EXHIBIT 3

Cover Sheet

DRAINAGE CONTROL PLAN
SHORT DUPLEX
13404 NE 100th STREET REDMOND, 98033

SITE PLAN

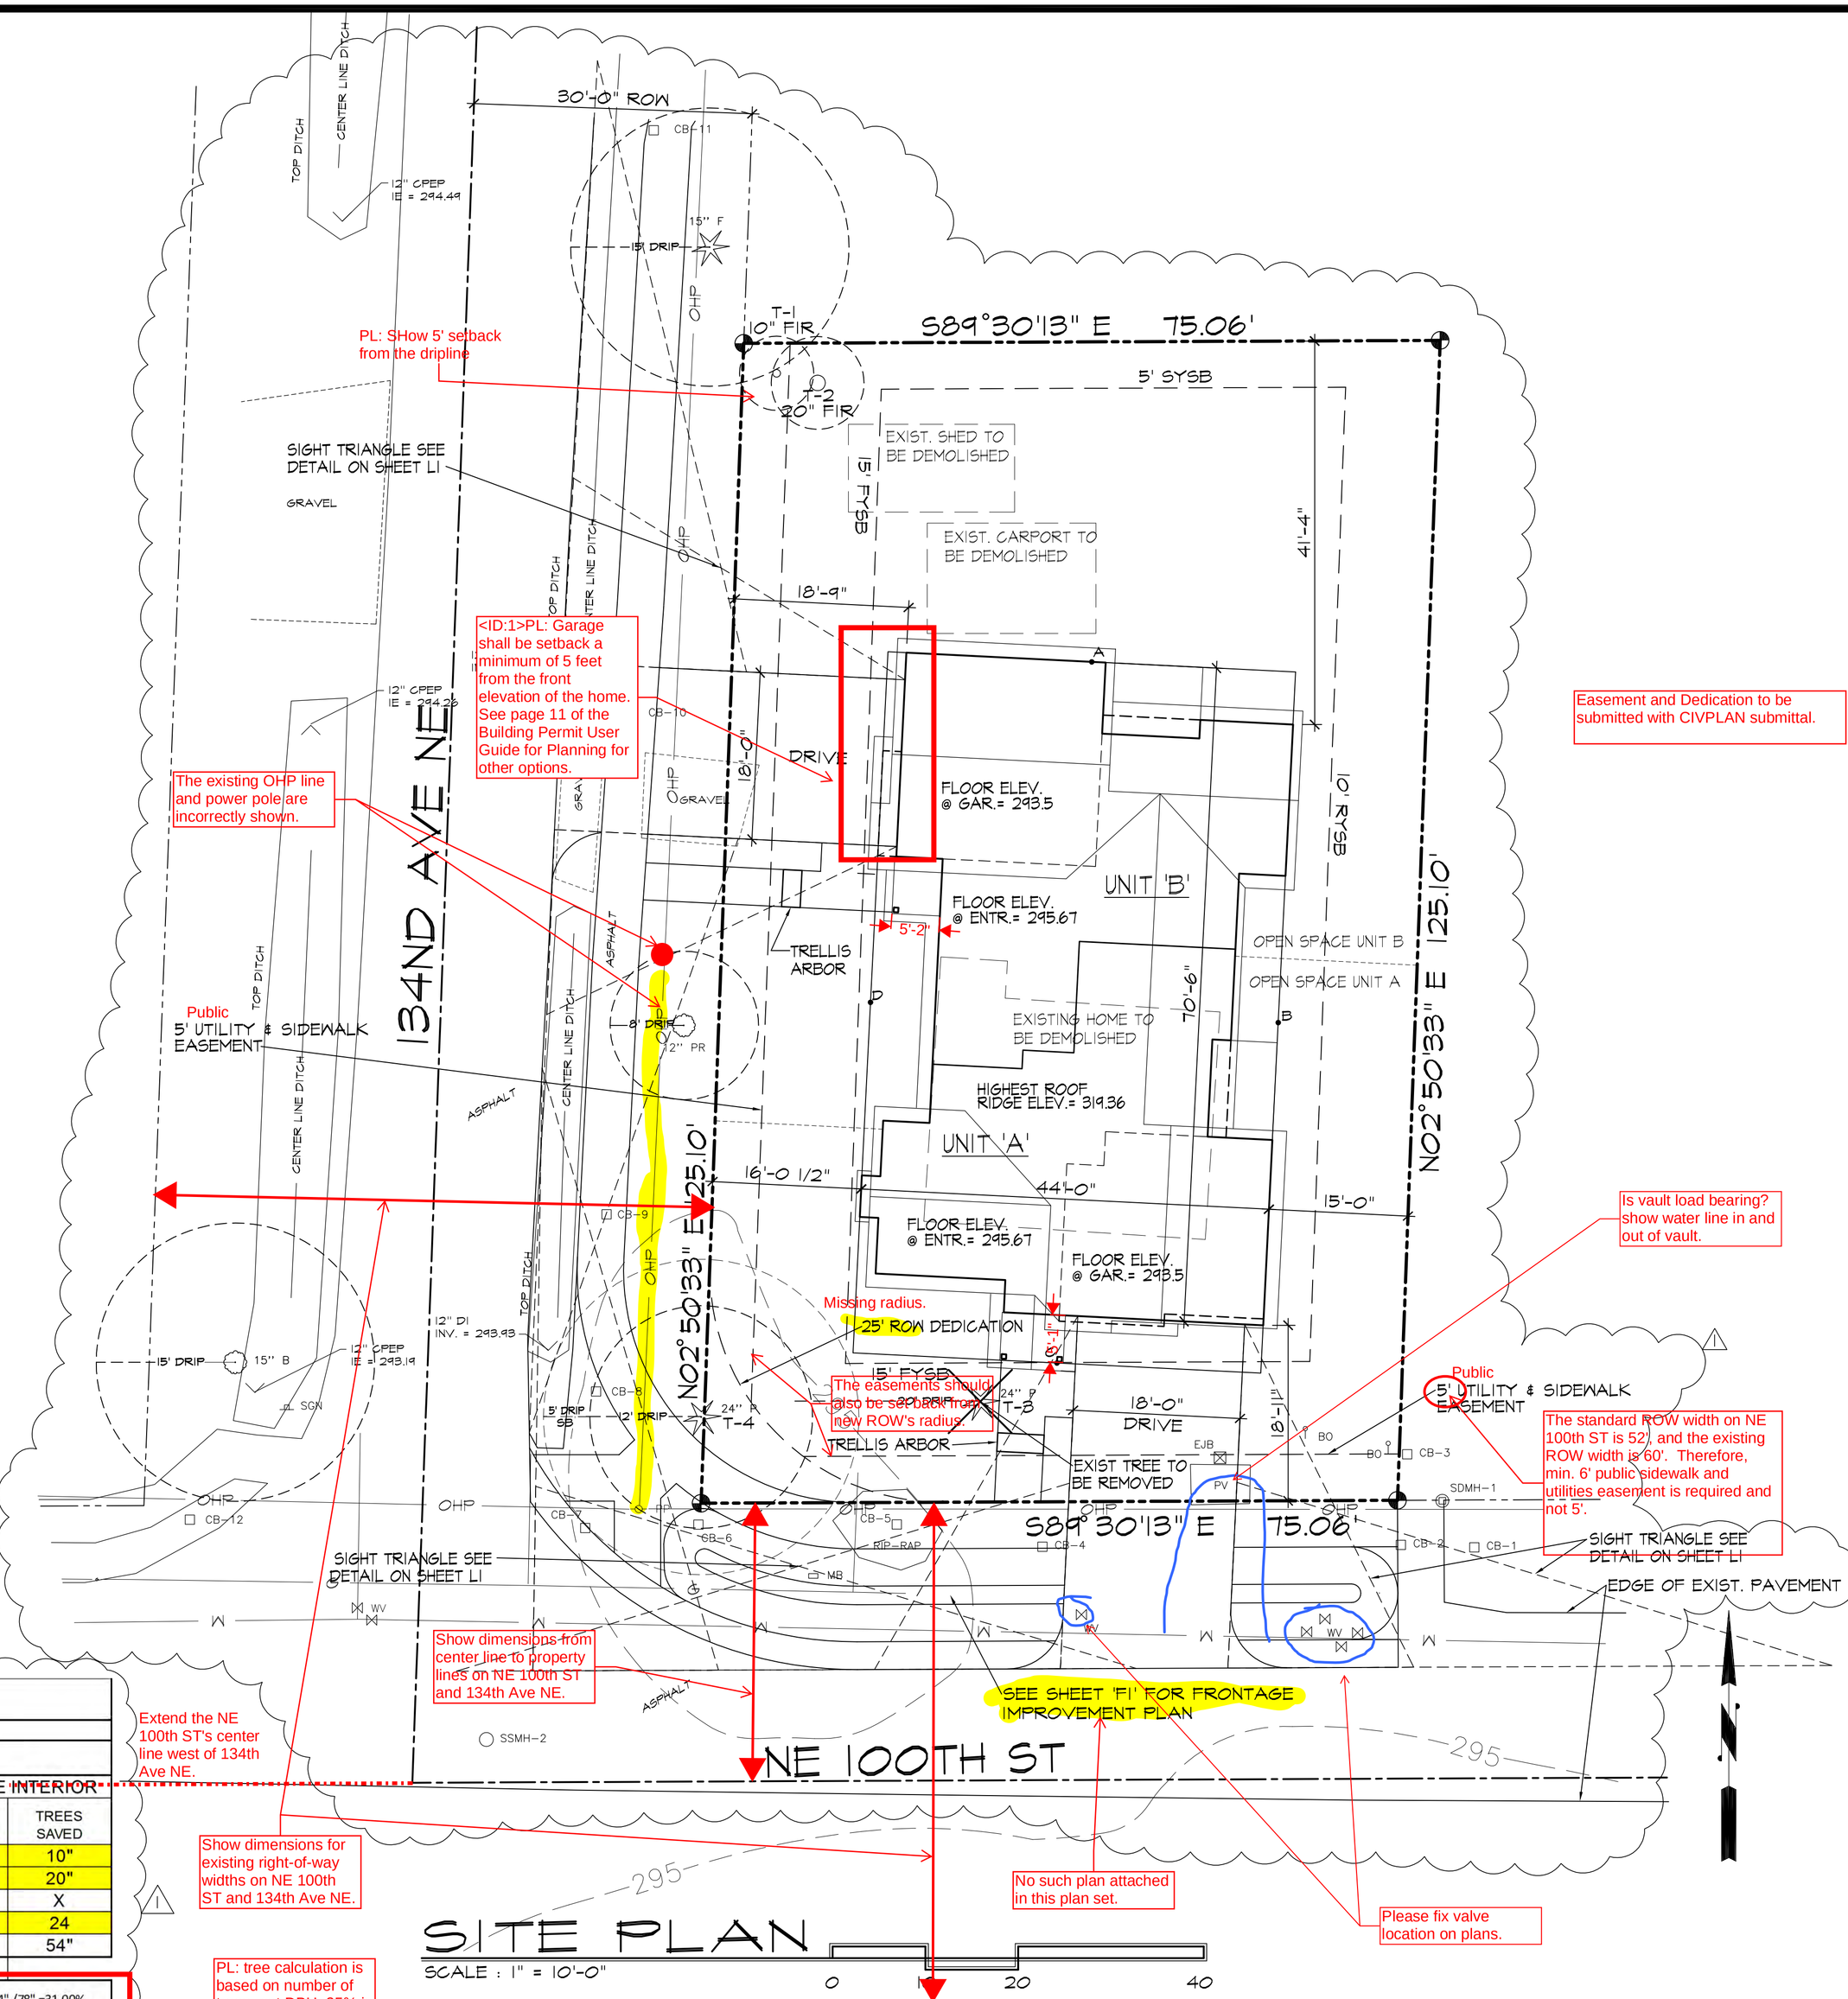
PL: SHow 5' setback from the dripline

<ID:1>PL: Garage shall be setback a minimum of 5 feet from the front elevation of the home. See page 11 of the Building Permit User Guide for Planning for other options.

Is vault load bearing? show water line in and out of vault.

Show dimensions from center line to property lines on NE 100th ST and 134th Ave NE.

Show dimensions for existing right-of-way widths on NE 100th ST and 134th Ave NE.

No such plan attached in this plan set.

Please fix valve location on plans.

Easement and Dedication to be submitted with CIVPLAN submittal.

DRAINAGE CONTROL PLAN

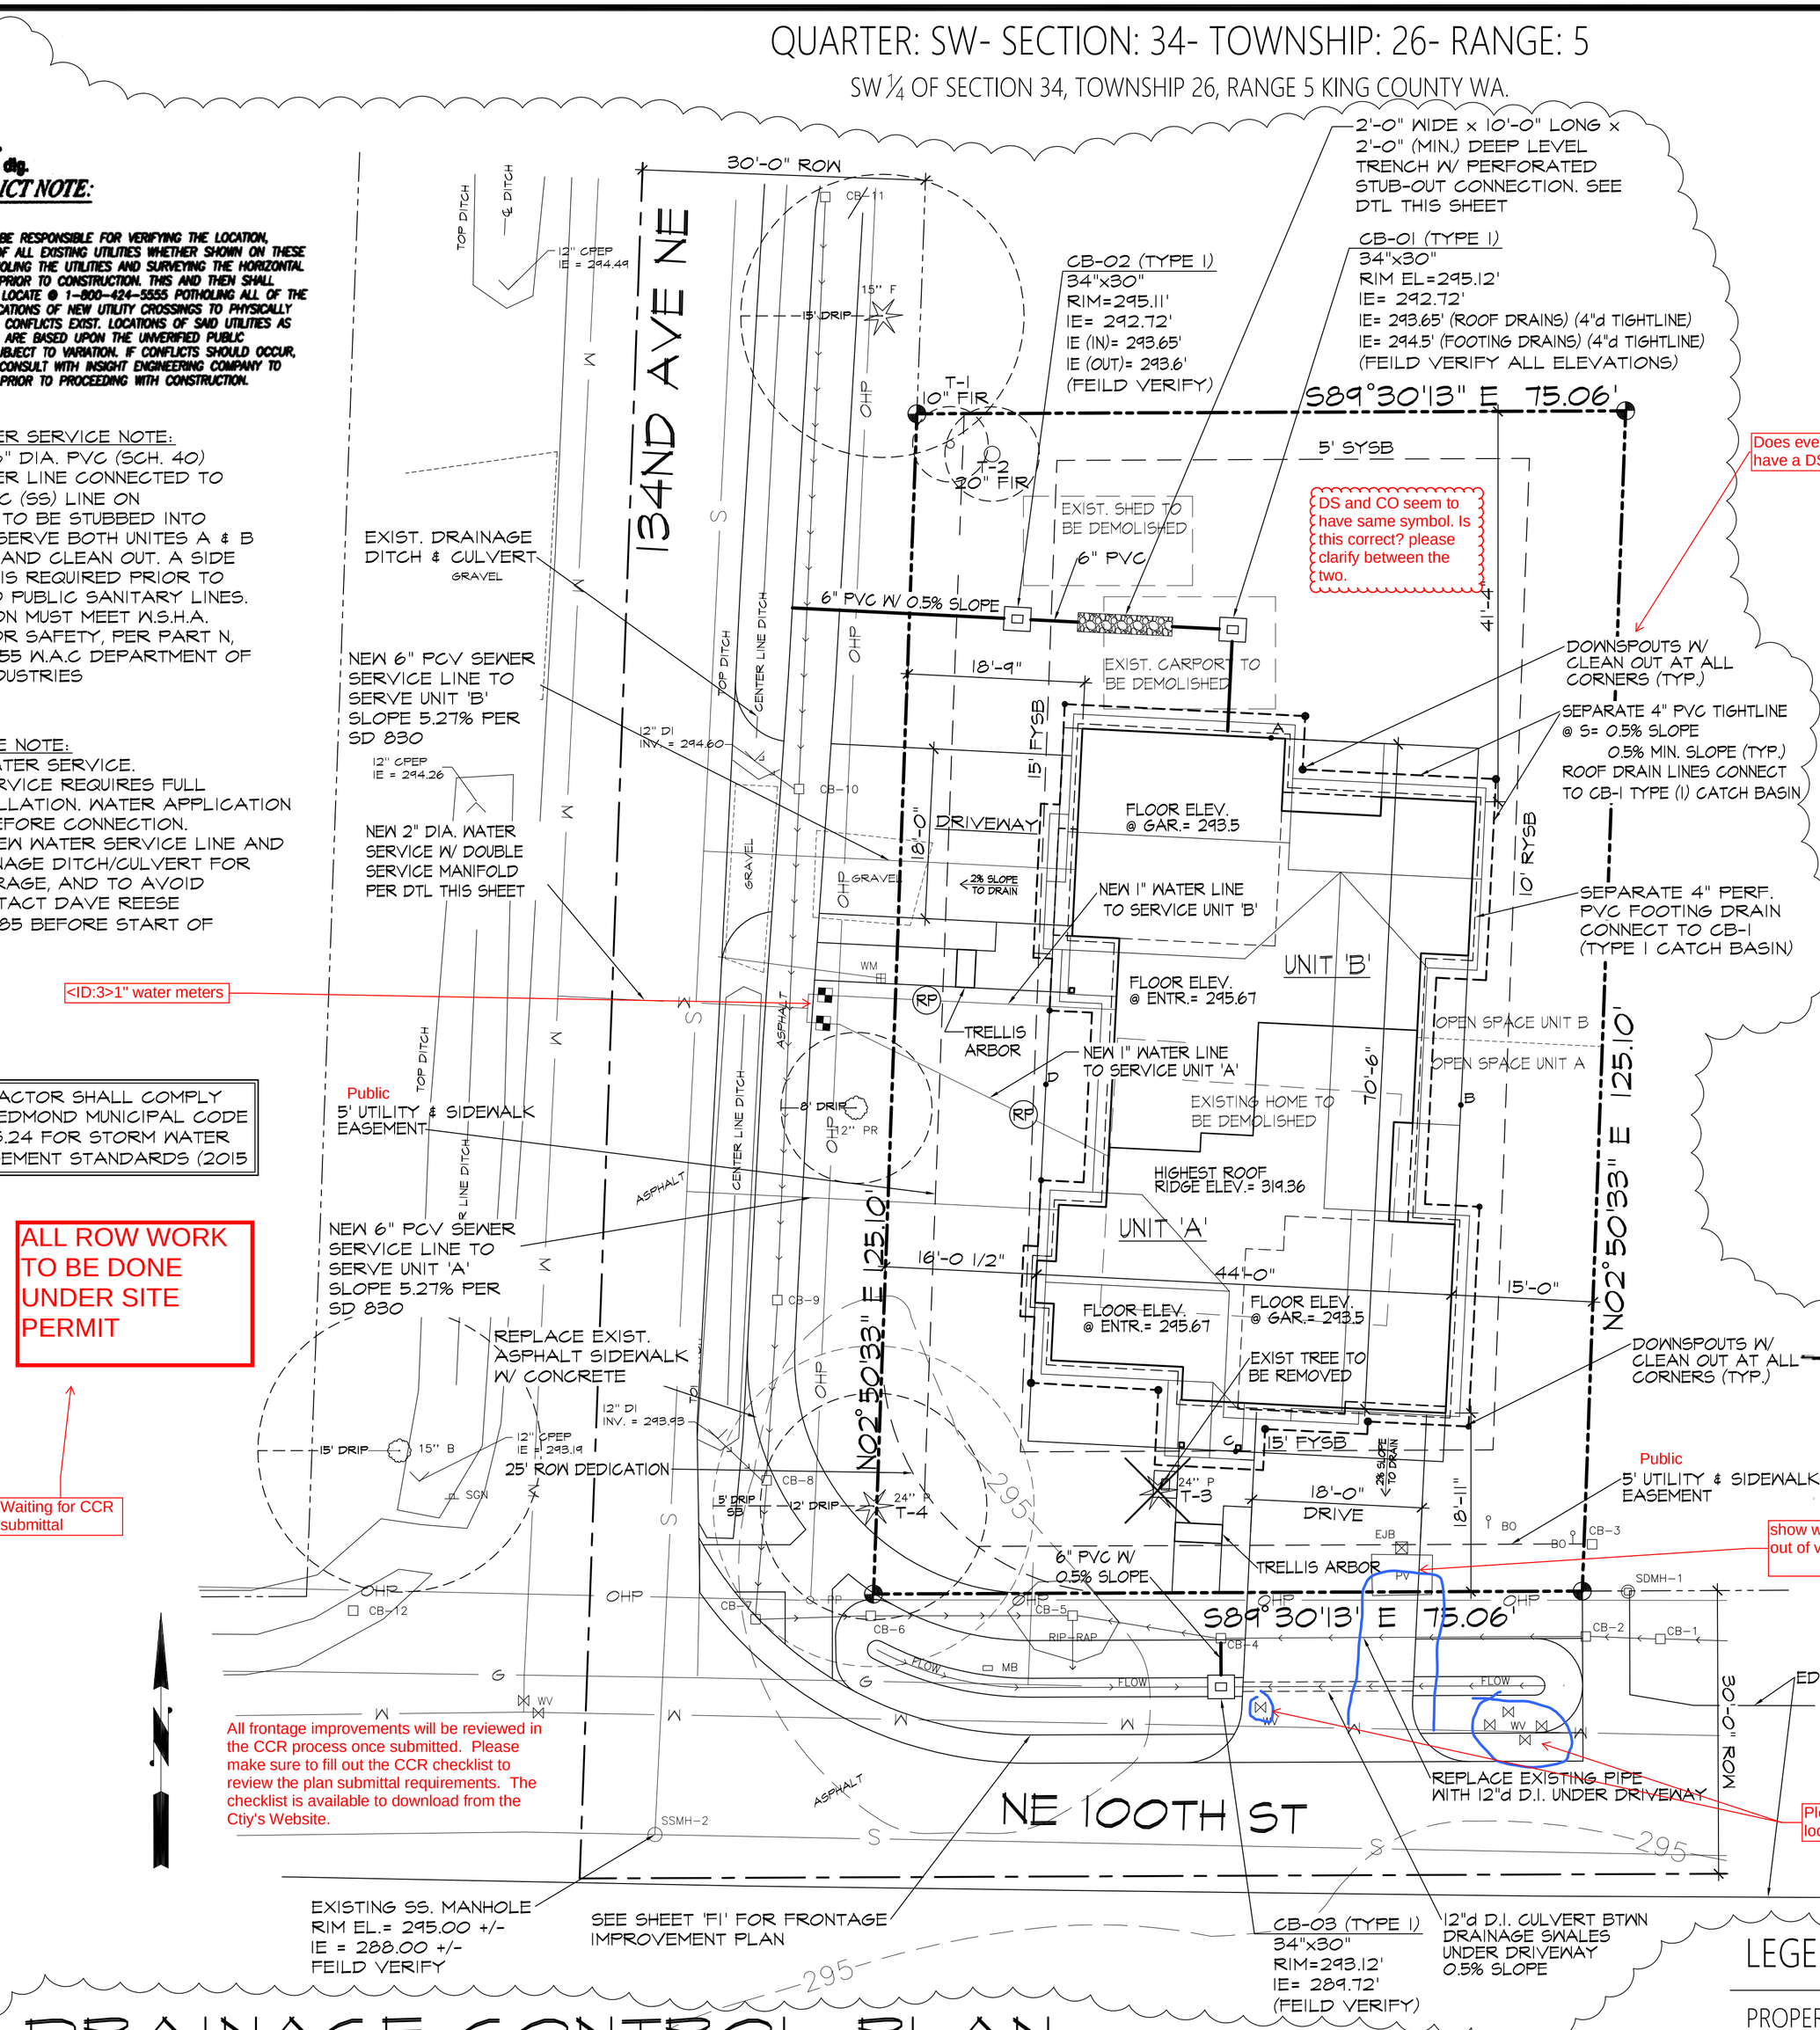
Waiting for CCR submittal

TEMPORARY EROSION & SEDIMENTATION CONTROL PLAN

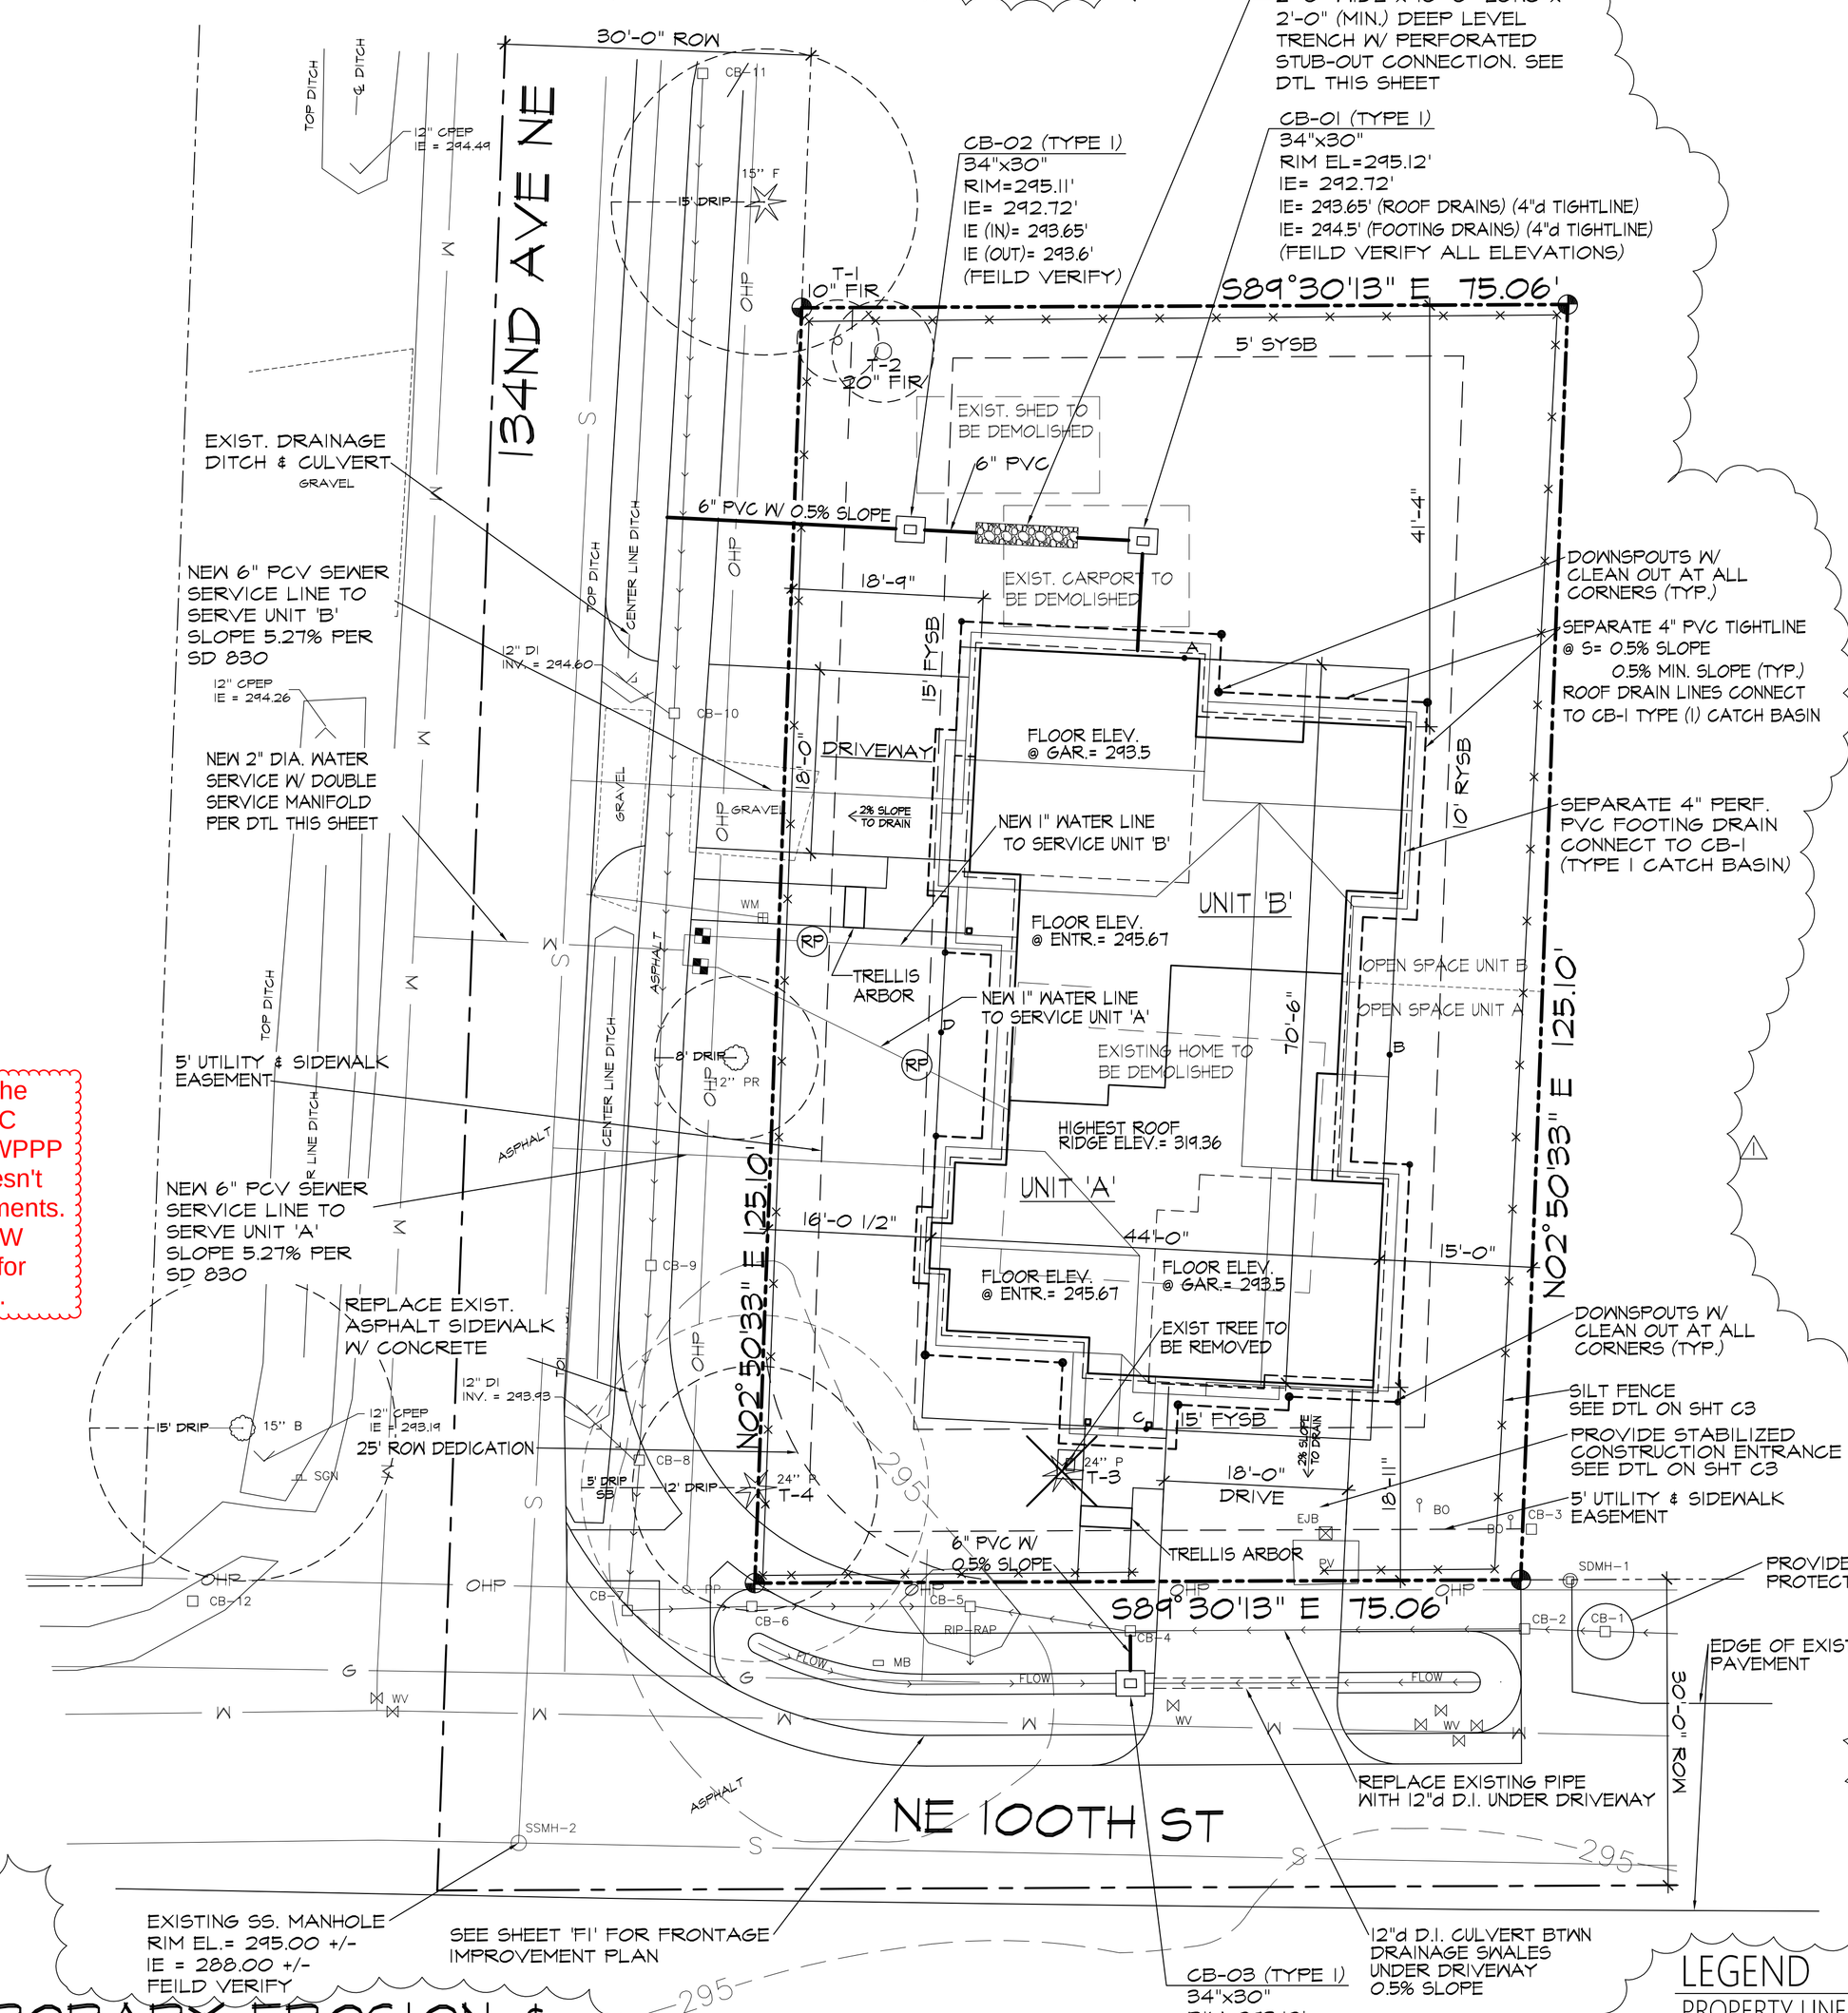
This plan is the same as the page before but with TESC note. Please provide a SWPPP and a TESC plan that doesn't show all the site improvements. SWPPP should cover ROW and on site work. Submit for both BPLN and CIVPLAN.
